SUBJECT: ADDENDUM ONE FOR DE00109 – U-5118EN, SIGNAL INSTALLATION AT THE FOLLOWING INTERSECTIONS: SR 2053 (JONES DAIRY RD) AT SR 2054 (CHALK RD) AND NC 55 AT SR 1111 (OLD POWELL RD) IN WAKE COUNTY, WBS ELEMENT: 42379.3.FD29

MEMORANDUM TO PROSPECTIVE BIDDERS

This addendum is being issued to change the contract time for this project, add Intermediate Contract Time Number 2, edit quantities for Line #0009, Thermoplastic Pavement Marking Lines (24", 120 mils) and Line # 0013, Removal of Pavement Marking Lines (24") and to distribute pavement marking plans.

NC55 AT OLD POWELL
PAVEMENT MARKING PLAN

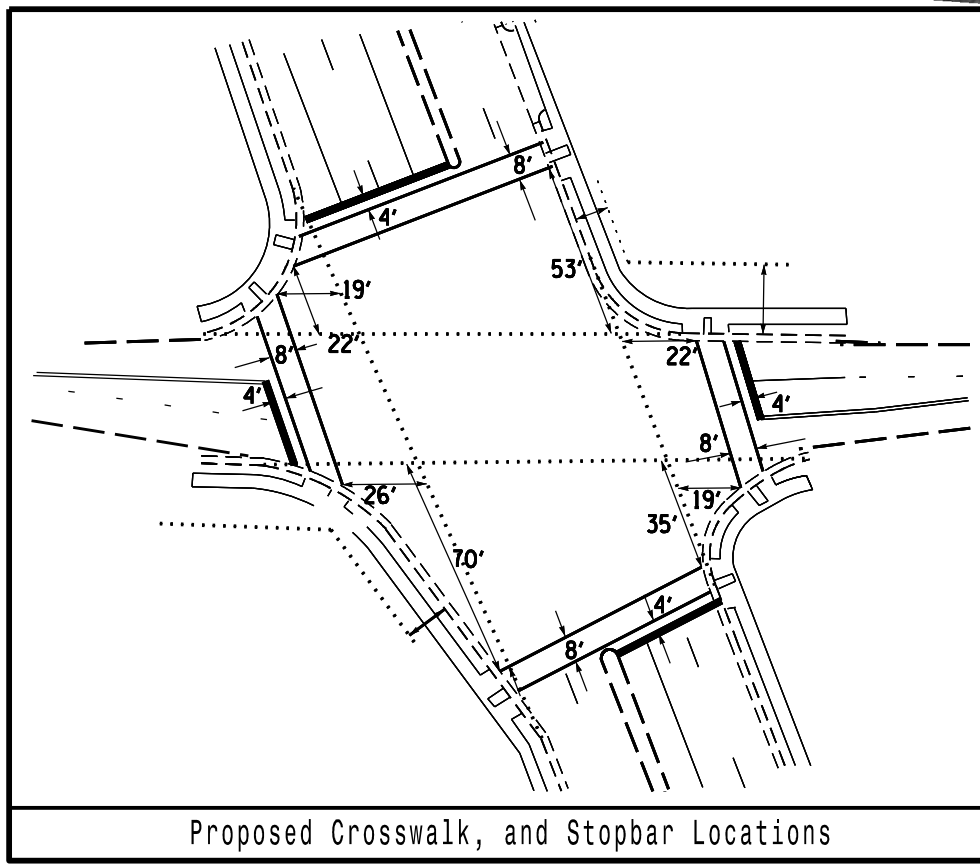
Plan sheets showing pavement marking and signing for the intersections are being transmitted with this addendum. Quantities for these items were included in the original proposal with the

exception of minor changes needed for Line #0009, Thermoplastic Pavement Marking Lines (24", 120 mils) and Line # 0013, Removal of Pavement Marking Lines (24").
